September 7, 2017
(Revised November 1, 2017)

**Subject: Response to Geotechnical Engineering Review Sheet
Ball Road Basin General Plan Amendment
Southeast Corner of Ball Road and South Phoenix Drive
Anaheim, California**

**GEOTECHNICAL ENGINEERING REVIEW SHEET
CITY OF ANAHEIM**

Section B - B' - Post Liquefaction Fill Option

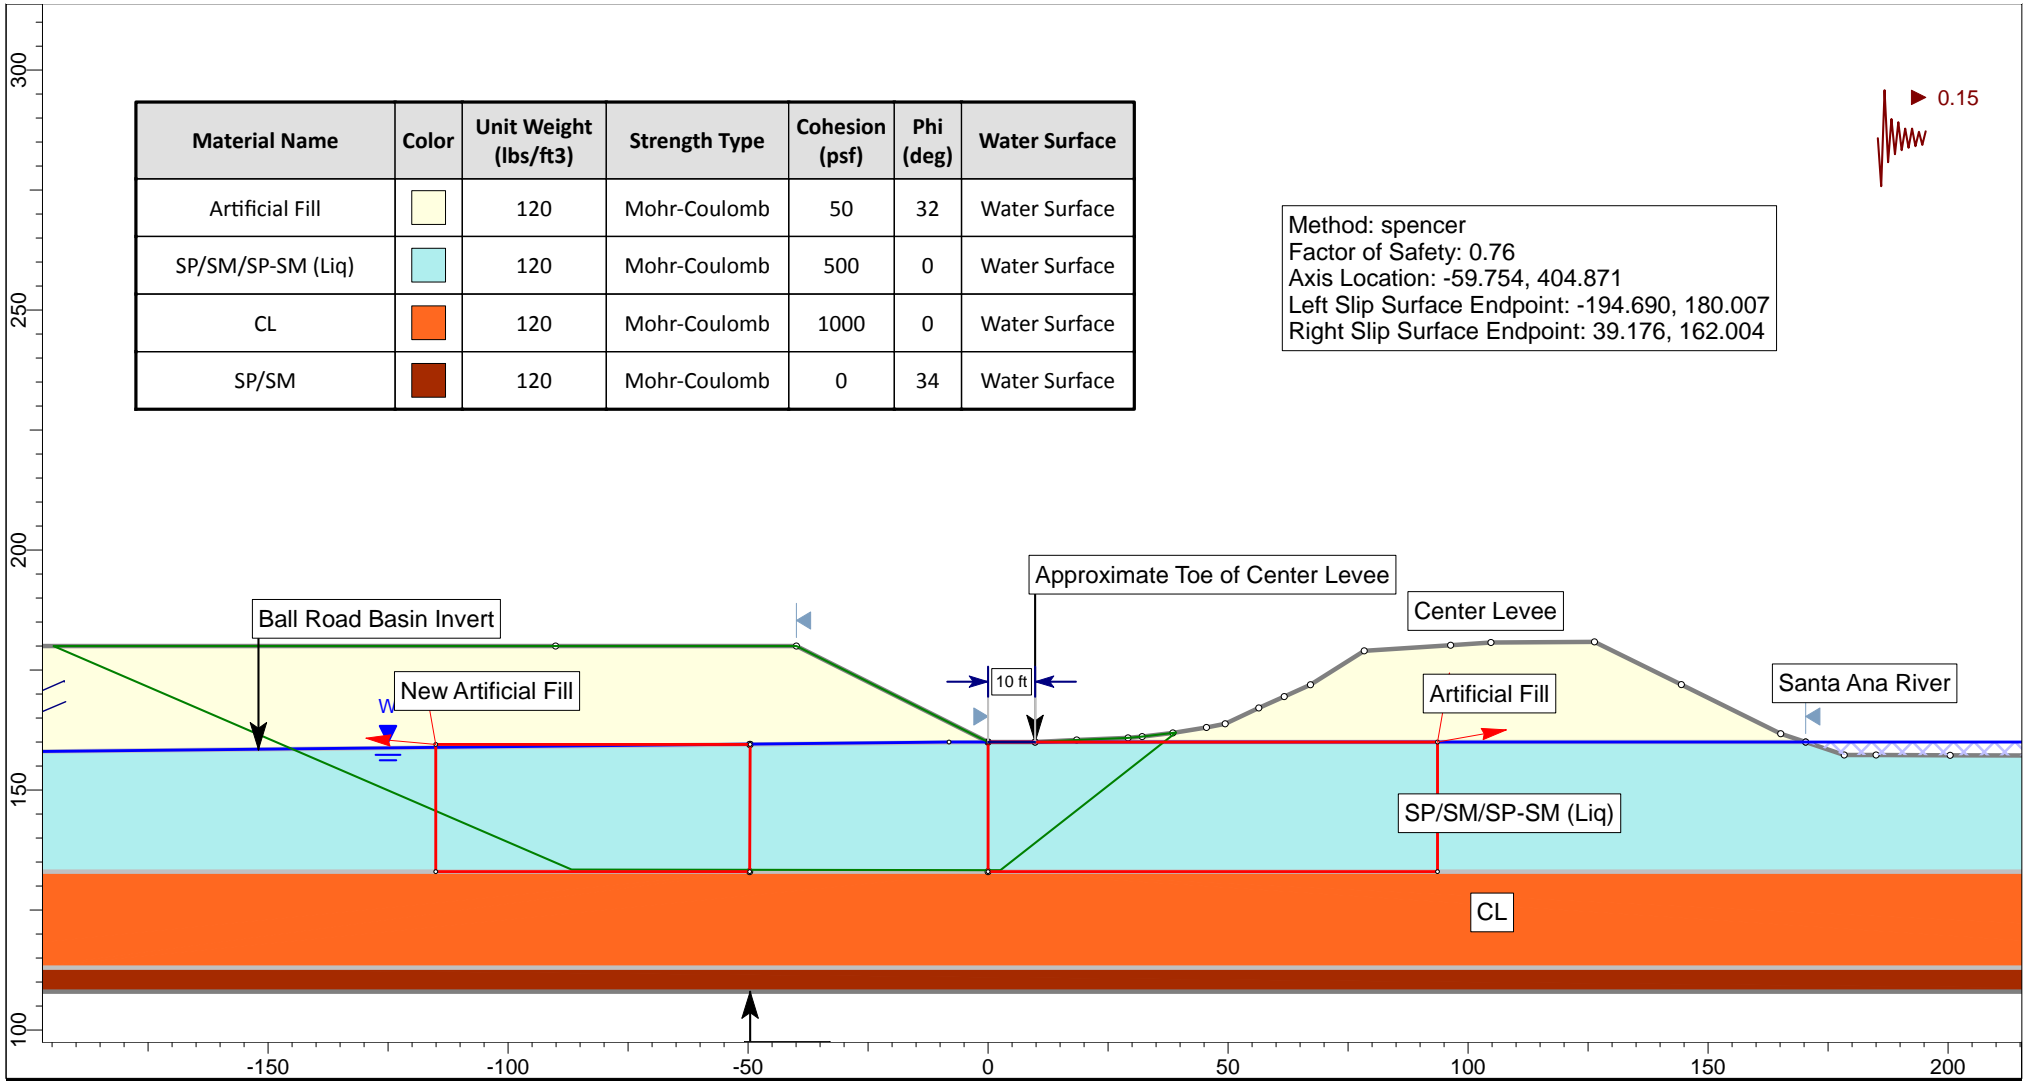
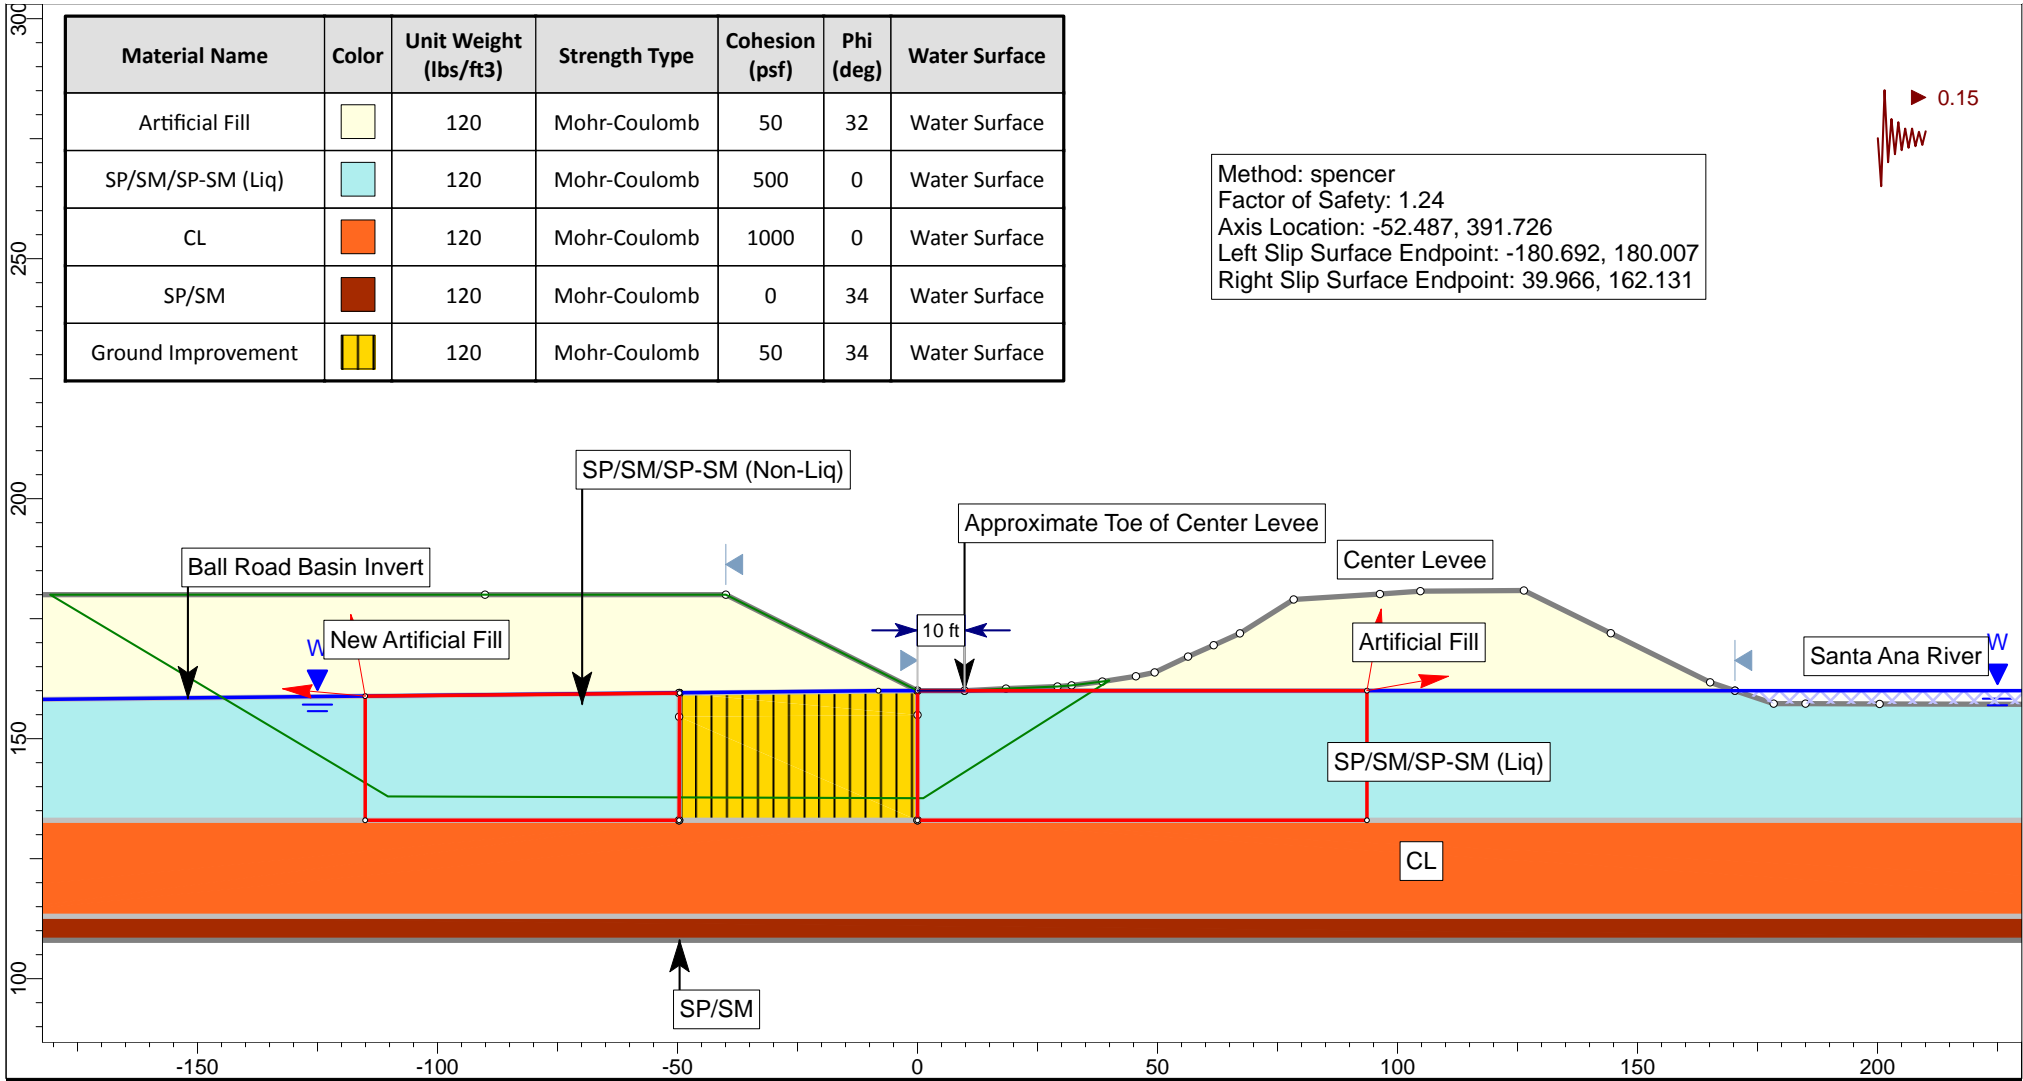
Comment 3: *Section 3.1.3 Secondary Effects of Seismic Shaking- Lateral Spreading- The site appears to present a significant potential for lateral spreading due to a loose sandy layer near an elevation of 155 feet. Should this layer be found to be liquefiable, lateral spreading could occur near the elevation of the adjacent river bottom making for a particularly unstable configuration. The consultant has not provided any analyses to evaluate the potential magnitude of lateral spreading. If the magnitude of lateral spreading is large, the mitigation could require large-scale costs to implement. The consultant should provide a quantitative analysis of the potential for lateral spreading and address in more detail the potential method(s) of mitigation, if required.*

Response to Comment 3: Slope stability analysis was conducted on Cross-Section B-B' (see Appendix A) to evaluate the potential for lateral spreading. The shear strength parameters used in the analysis were obtained from direct shear test results, correlation with SPT blowcounts and relative density, and CPT data. The sand underlying the basin down to Elevation 134 feet is potentially liquefiable and is modelled with a post liquefaction residual strength of 500 psf. The calculated factor of safety for a pseudostatic condition with liquefied soils was less than 1.0 (see Appendix A). Ground improvement may be performed to reduce the potential for lateral spreading. For planning purposes, the ground improvement area is estimated to be approximately 50 feet wide, extending to a depth of 25 feet. Slope stability analysis with this preliminary ground improvement layout is also presented in Appendix A.
